MISSISSIPPI RIVER-GULF OUTLET,
LOUISIANA

DESIGN MEMORANDUM NO. 1-C, CHANNELS
SUPPLEMENT NO. 1
STONE RETENTION DIKE EXTENSION

LMVED-TD (NOD 11 Jan 66)

SUBJECT: Mississippi River-Gulf Outlet, La., Design Memorandum No. 1-C,
Channels, Supplement No. 1, Stone Retention Dike Extension

MISSISSIPPI RIVER GULF OUTLET, LA.
 DESIGN MEMORANDUM NO. I-C, CHANNELS
 SUPPLEMENT NO. I
 STONE RETENTION DIKE EXTENSION
SHOALING RATES
 MILE 6.2 TO MILE 23.15
 U.S. ARMY ENGINEER DISTRICT, NEW ORLEANS
 CORPS OF ENGINEERS
 DATE JANUARY 1966 FILE NO. H-2-23725

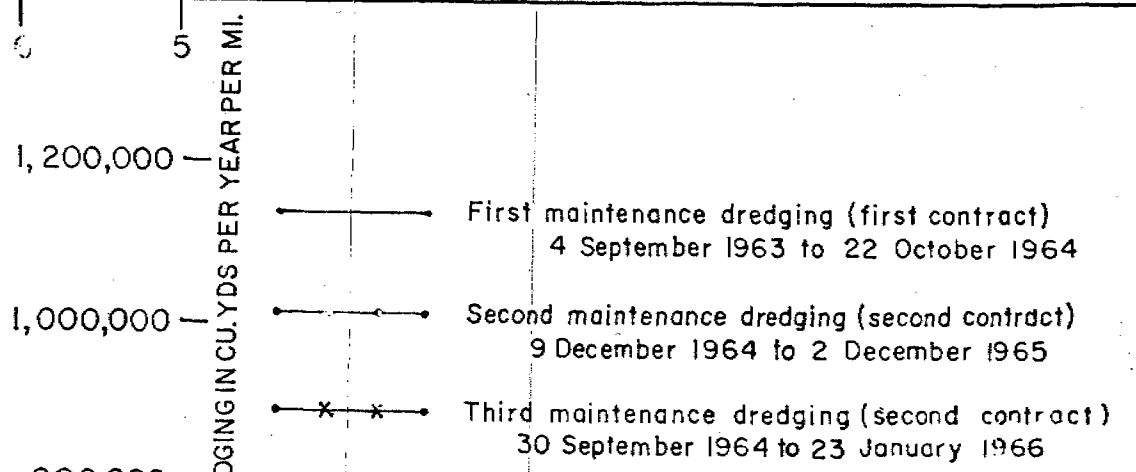
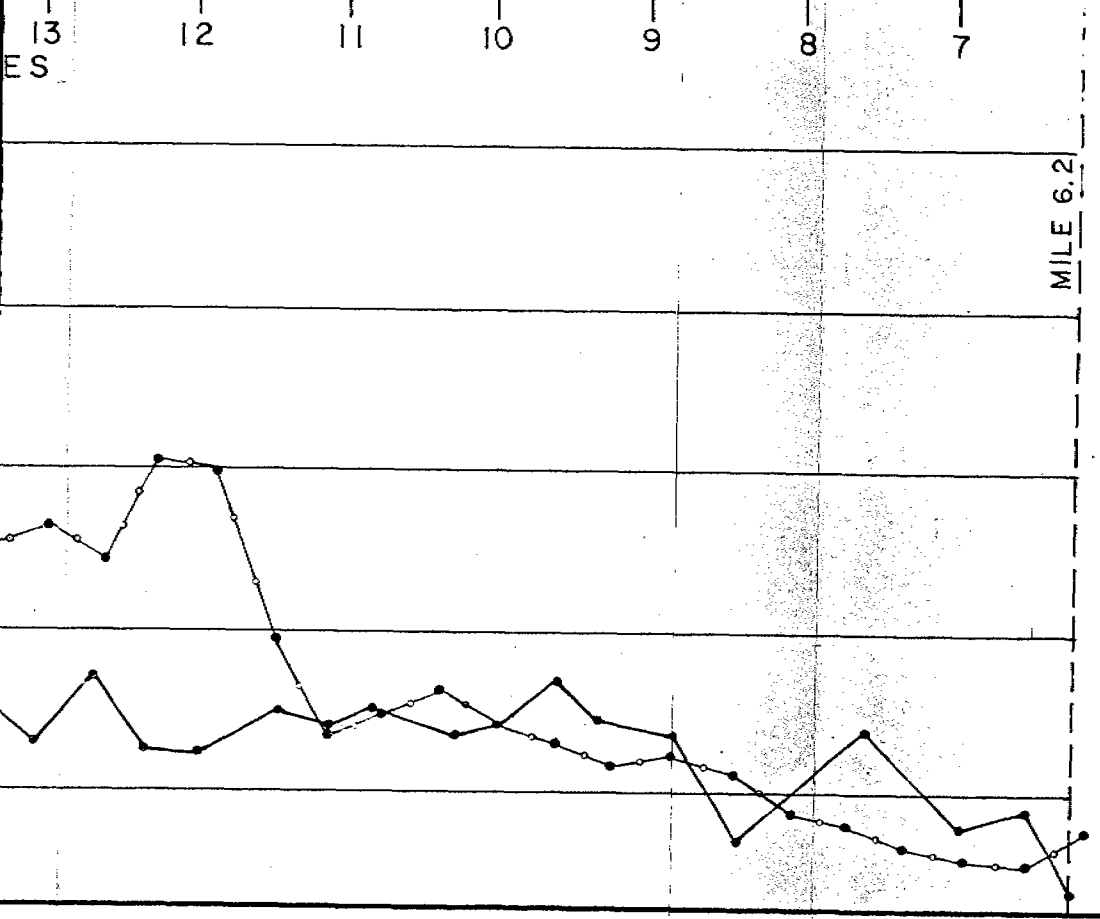
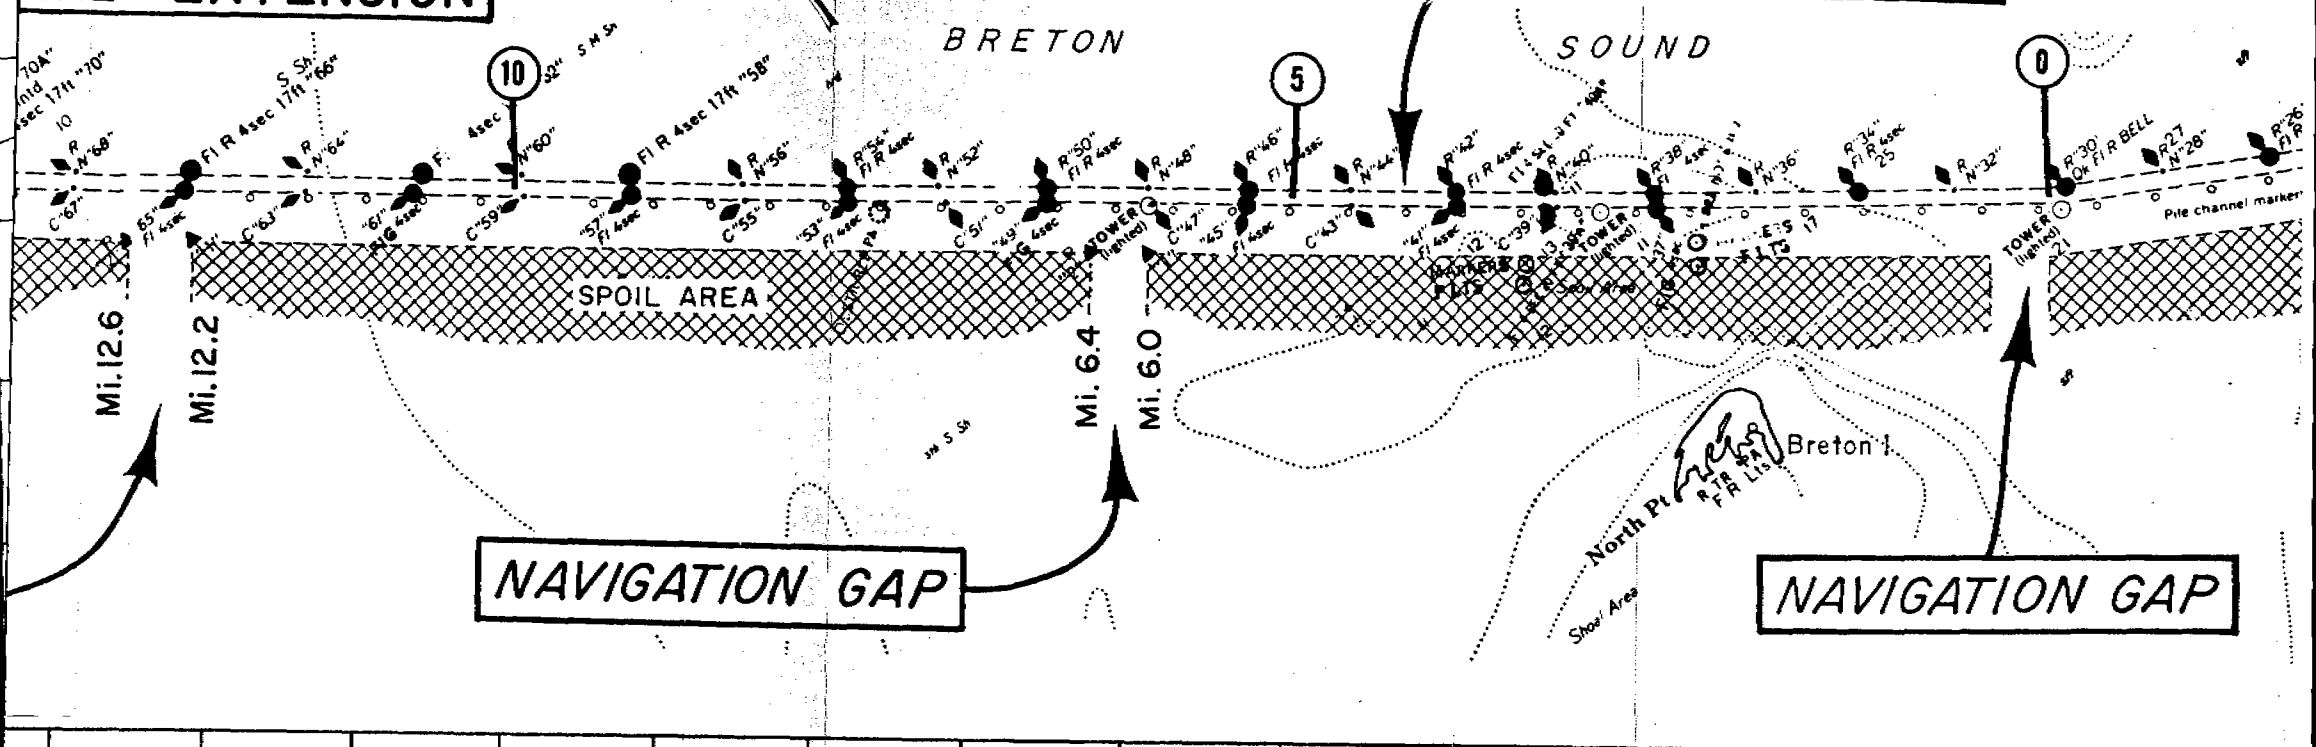
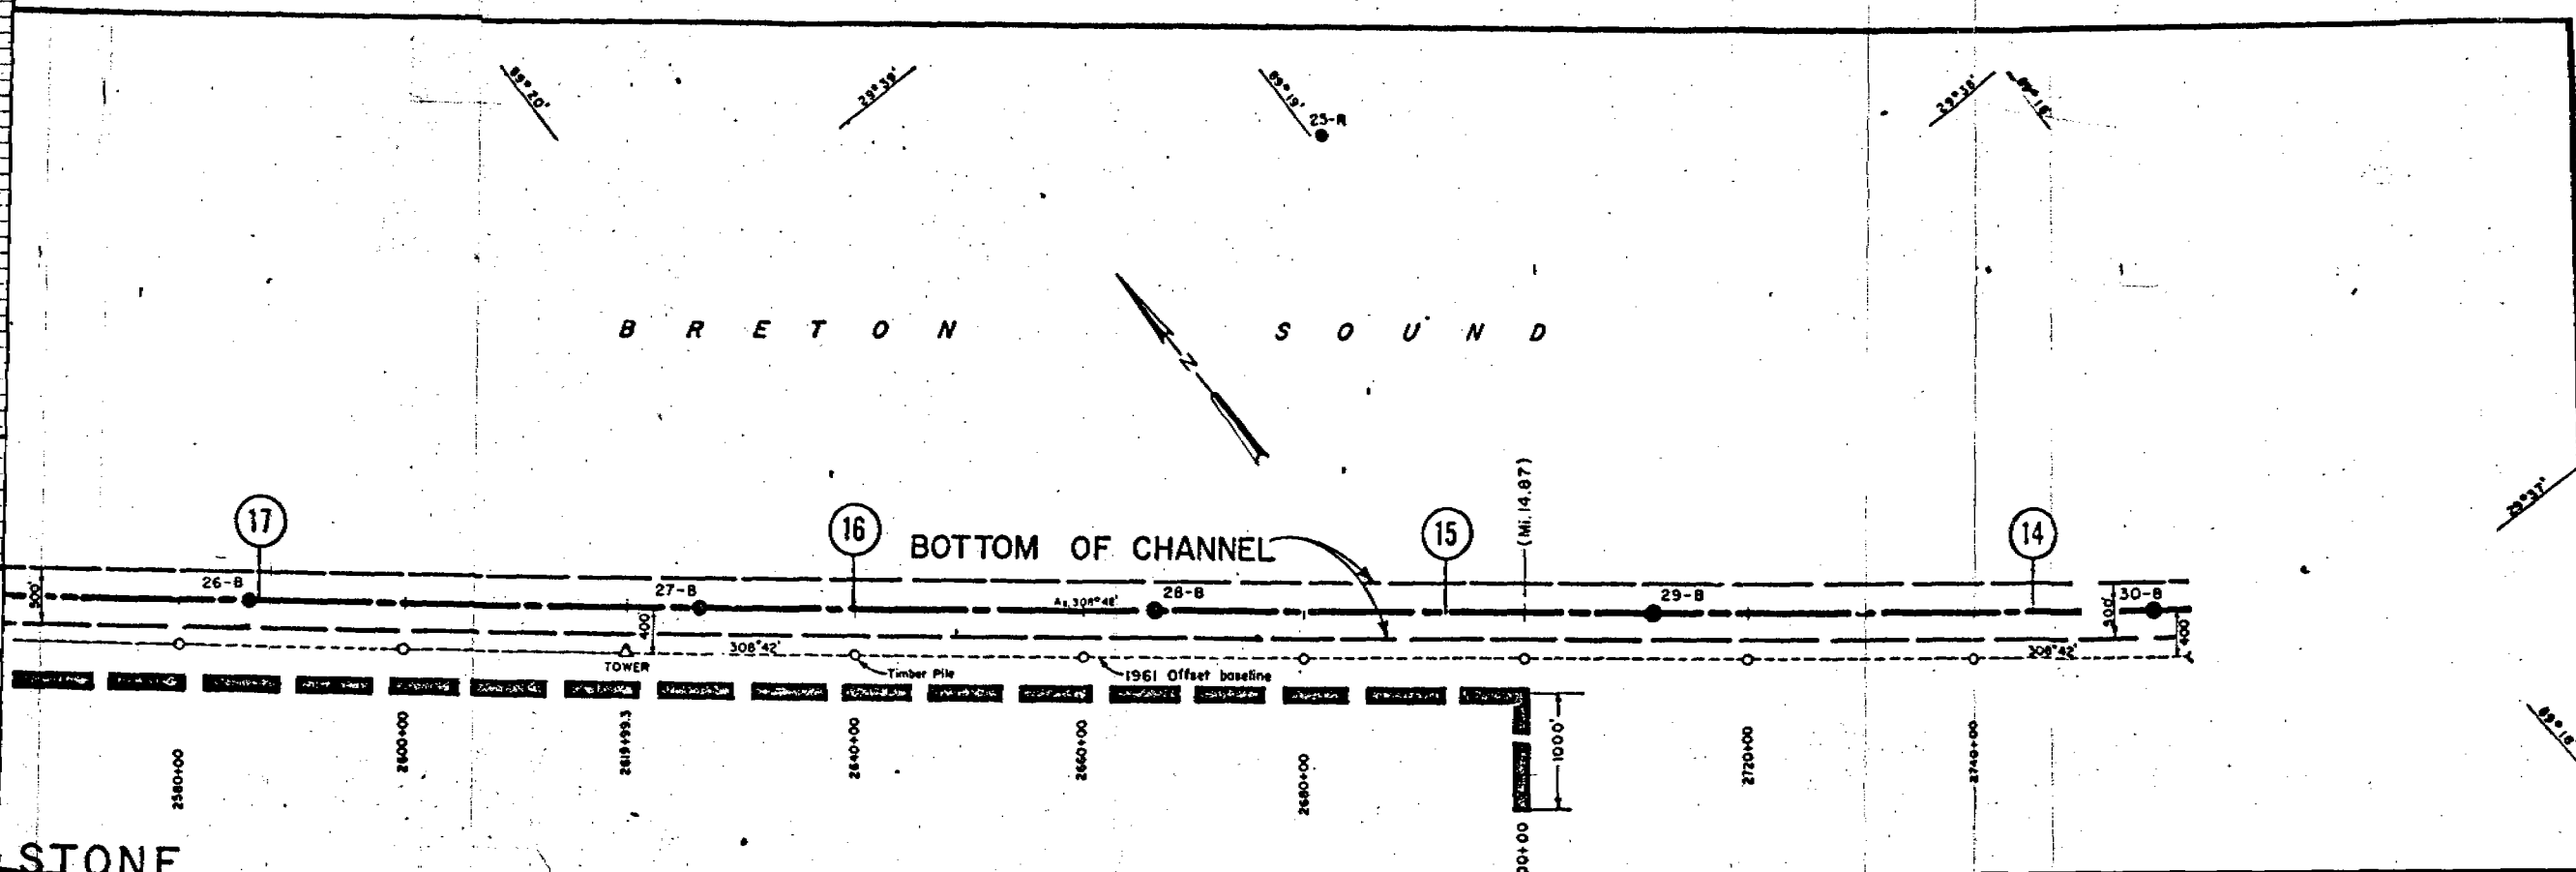
1. Subject supplement is approved as recommended. Our review comments follow.
2. Table 2 Page 4. The direction of current should be clarified as to whether the azimuth is from north or south. It should also be clarified as to whether the current is from or toward the given direction.
3. Plate 2. The tower numbers should be shown.
4. Plate 3. The end of existing south dike should be designated on the plan and profile.
5. Plate 4: a. The south side borrow pit for cast fill should be shown on Phase I section.
b. The slopes for Phase II section should be shown.
